A Submission by EcoTransit Sydney to the

**CBD and South East Light Rail
Environmental Impact Statement**

Prepared by EcoTransit Sydney
9 December 2013

CBD and South East Light Rail Project – SSI 6042
23–33 Bridge Street,
Sydney NSW 2000

Figure 2: Stop with split (offset) side platforms

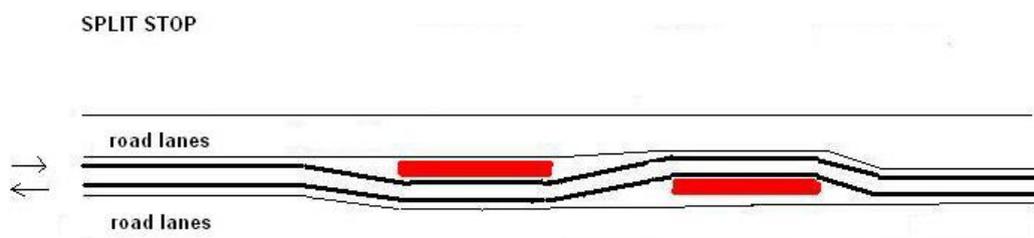
That smaller total platform footprint of a centre-island (compared to two side platforms) means less space on the platform for a crowd of passengers and having conflicting flows clashing, rather than being separated. The centre island has to handle twice as many people as a side platform, without the advantage of twice as much width, because it is used to reduce lateral width. If a tram in one direction is loading or discharging a particularly large load, a tram in the opposing direction may have to stand off the platform until the crowd clears (observation from Adelaide). This undermines on-time running.

There are significant safety issues associated with centre-island platforms. There is no fence to act as a backstopper to prevent people being pushed off the platform by a crowd. Trams on centre-island platformed systems (like Adelaide and Dublin) have recorded incidents of wrong-side door openings, meaning there is a safety hazard of passengers (particularly young children) unwittingly stepping out into road traffic. As failsafes, fencing would be needed between the tramlines and the traffic lanes and trams would need to be fitted with software that remembers the route and ensures that the doors are opened on the correct side – an additional upfront and ongoing cost.

Side platforms will handle large crowds without conflicting movements. A side platform is dealing with the crowd travelling in one direction only, not two – half as many people as a centre-island platform has to handle, yet the centre-island is typically little wider than a single side platform.

Key recommendation: All stops be designed to conventional tramway standard, that is, with side platforms, whether facing islands, staggered islands, Vienna stops or stops with platforms incorporated in the footpath.

Figure 6: Circular Quay loop

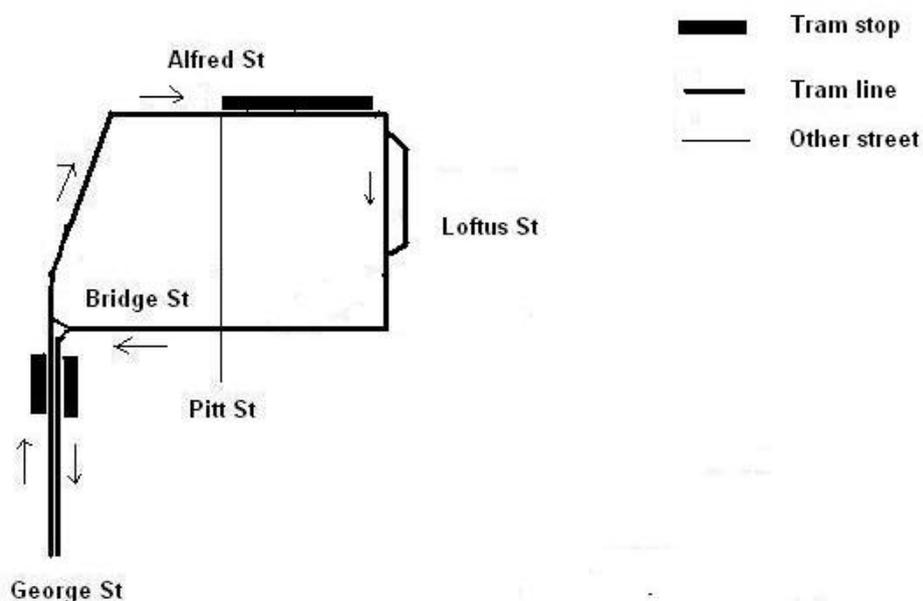
This would return more of the Alfred Street space to pedestrian plaza and remove the “railway marshalling yard” appearance created by the present terminus design. Except as described in the next paragraph, there would be no layover at Circular Quay and the trams would loop continuously in and out. The layover (including driver rest breaks) would be at the outer termini.

After leaving the platform, trams would turn into Loftus Street, then Bridge, then back into George. (A shortcut is possible via Macquarie Place if desired.) A siding loop/layover can be provided in Loftus Street to enable any out-of order trams to pass each other, or to hold trams on standby to meet additional needs (e.g. during special events). These trams can return to the Quay on the loop via Bridge and George Streets, back to Alfred Street. In the longer term, a return on the loop can be built via Pitt Street. This would enable more trams to be held in reserve for special events and fed in more quickly.

- The Circular Quay terminus should be redesigned as a loop via George, Alfred, Loftus and Bridge Streets, with a holding siding in Loftus Street (section 4.2.1.1 refers).

Figure 7: Kingsford loop

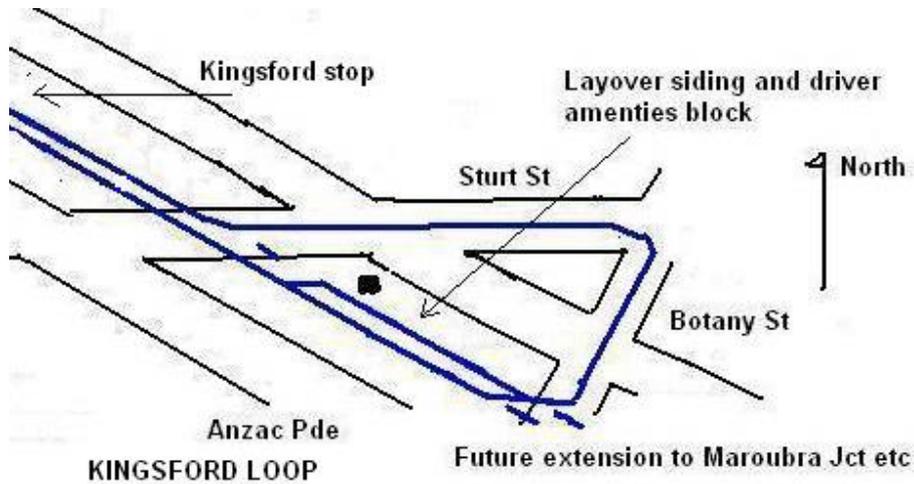
In the future, in the event of a long-distance extension served by unidirectional trams with more seating, in order to short-work UNSW services without reversing, trams can loop via

Sturt and Botany Streets, back to the central reserve between Botany and Sturt Streets. At present, however, this loop would be a low priority.

Figure 9: Randwick loop

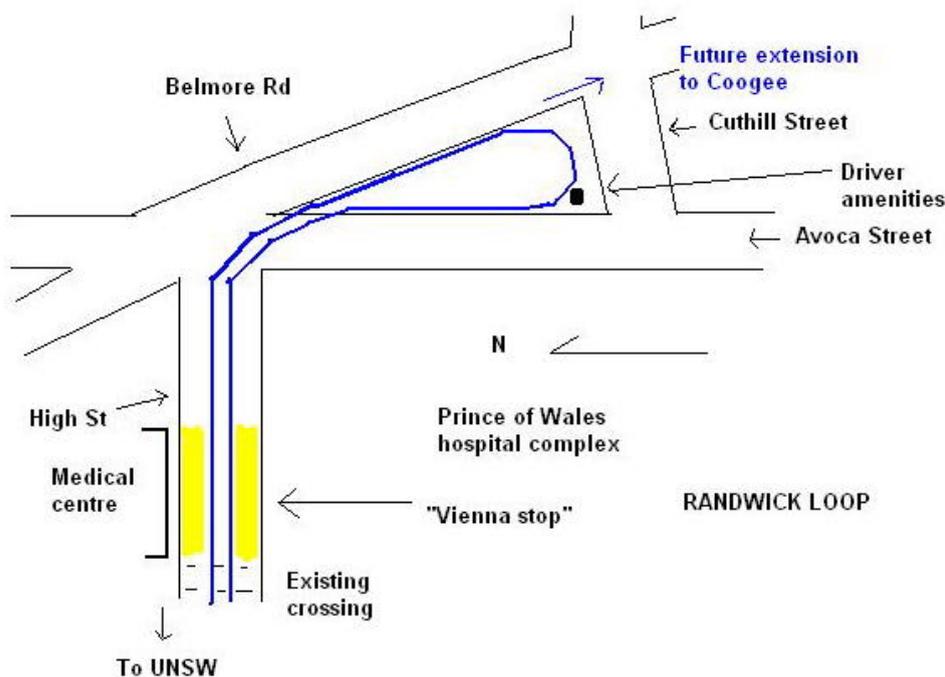
High Cross Park is an ideal site for a loop and layover (with drivers' amenity building), which could be set in grass lawn and not destroy the park, as the present proposal does. It is not the place for a stop – which should be in High Street to directly serve the hospitals and shops – but it is recognised that the initial intention is to provide a bus interchange. However, if the line is extended to Coogee, the need for this interchange should significantly diminish, but the loop can remain as a turning-point, for example for UNSW peak services.

Section 4.3.7 in this submission deals with the need for a stop in High Street which can service residual bus interchange should the line be extended to Coogee.

Figure 10: Central Station loop

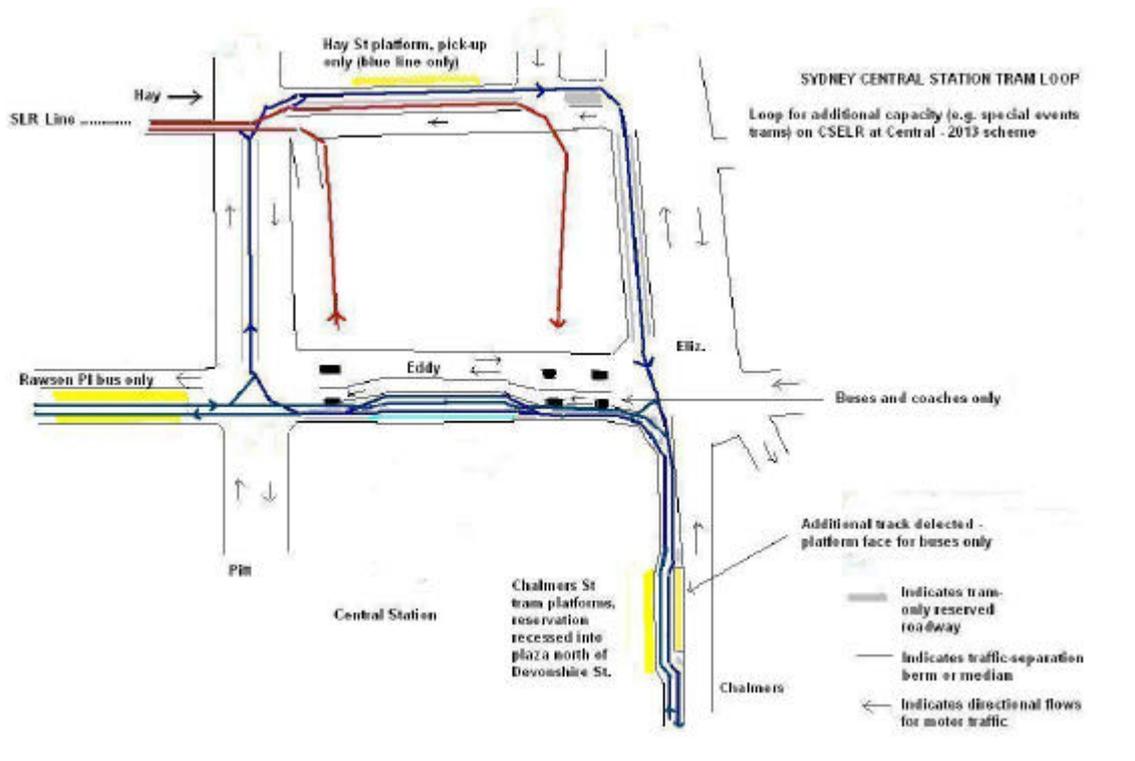
Loops can hold a number of trams on standby that can be fed into the stop as required. Being separated from the service line, trams can be stored around this Central loop (as well as in the Eddy Avenue siding if it is retained). Thus, there is no need for the additional platform face in Chalmers Street (and it can thus be permanently used as a bus stop), as trams can be fed into the stop from the loop immediately, as needed.

As there would be two reserved tram tracks in Hay Street, it is proposed that there be only one traffic lane, westbound on the southern side. There is also scope for connections via this loop to and from the Inner West Light Rail should any through-routing to the south-east be required, as outlined in section 3.1 above. A platform can be incorporated in the footpath on the northern side of Hay Street to serve the loop should it be required in any special circumstances.

Key recommendation: A special-event turning and holding loop should be built at Central Station, around the streets surrounding the perimeter of Belmore Park.

Figure 11: Moore Park special events loop and stop

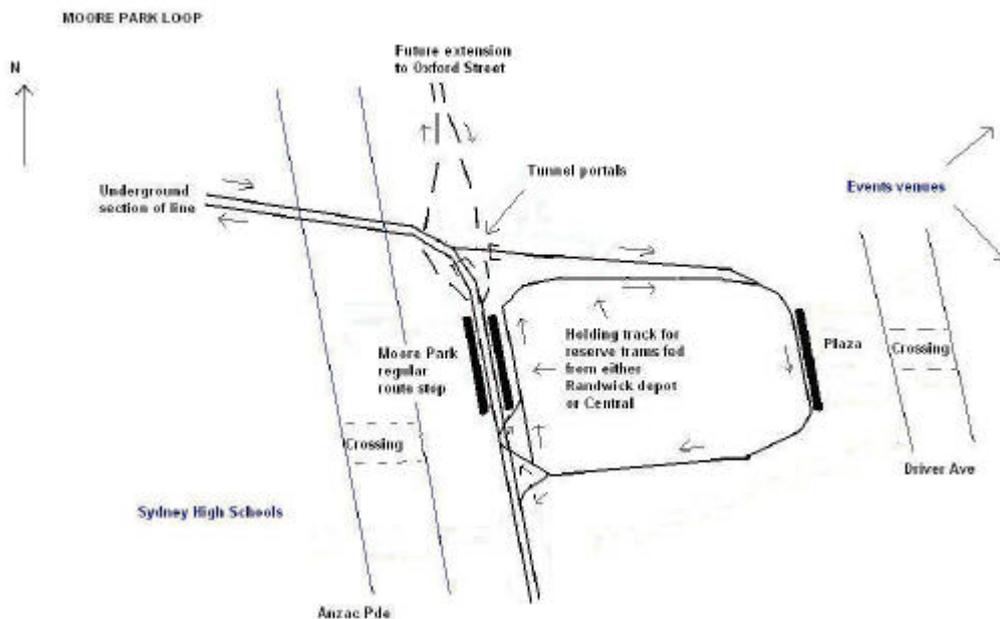
There would be a long (90+ metres) nearside platform on the eastern side of the loop, adjacent to Driver Avenue – merging into the pedestrian plaza and bringing patrons up close to the venues and without having to cross any tram tracks.

The Moore Park regular stop would remain as a stop for the route services only and would serve normal daily needs of the high schools and the entertainment quarter. An overhead pedestrian bridge at the stop would not be needed. That said, an integrated pedestrian/cycle plan for Moore Park generally – including grade-separated crossing of Anzac Parade, logically a subway beside and built in conjunction with the CSELR tunnel – seems necessary in conjunction with the project.

Key recommendation: A special-event loop, with platform adjacent to Driver Avenue and a holding siding, should be built at Moore Park.

Figure 12: Randwick racecourse special events loop and stop

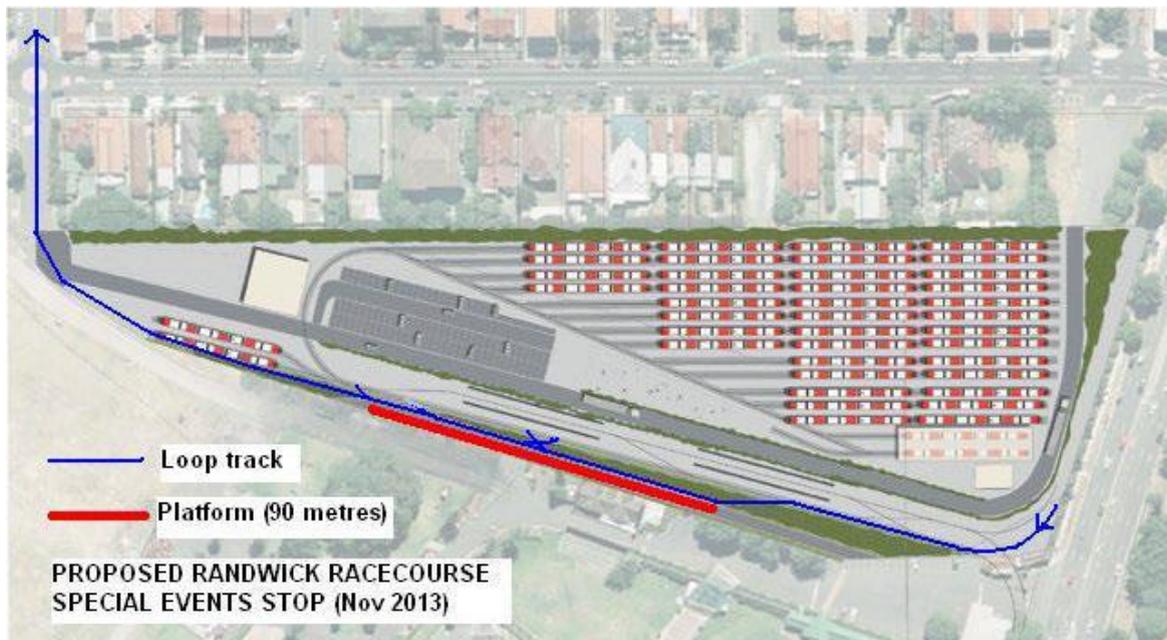
- Using the loop track within the depot fan, return to Alison Road via the westernmost storage track in the depot yard; or
- Follow the former tramway alignment out the Ascot Street gate and along that street to join the Kingsford line in Anzac Parade, Kensington.

The second option is the preferred one as it also offers the advantage of providing direct access to the Kingsford line from the depot so that trams can be dispatched to and returned from Kingsford terminus. The junction of the Ascot Street track and the Anzac Parade tracks would have turnouts in both directions to facilitate this. Under the present arrangement, there is direct access from the depot to the Randwick terminus, but trams to Kingsford have to go along Alison Road to Robertson Road at Moore Park and then reverse down the Kingsford line, a very impractical and time-consuming arrangement.

Minor adjustment would need to be made to the depot trackwork to accommodate this special event stop, but there is room for it and it offers advantages for normal daily dispatching and return of trams as well.
